MALT IDE - PCB V1.1 PATCH

The patch prevents a reboot of the MSX machine if the ROM enable/disable switch is toggled while the machine is on.

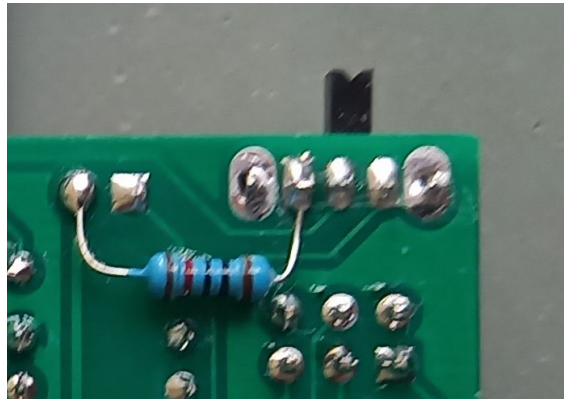
1. Cut the trace between the switch pin 1 and the LED +5V pin at the front side of the PCB
2. Solder a 10K resistor between switch pin 1 and the LED +5V pin at the back side of the PCB
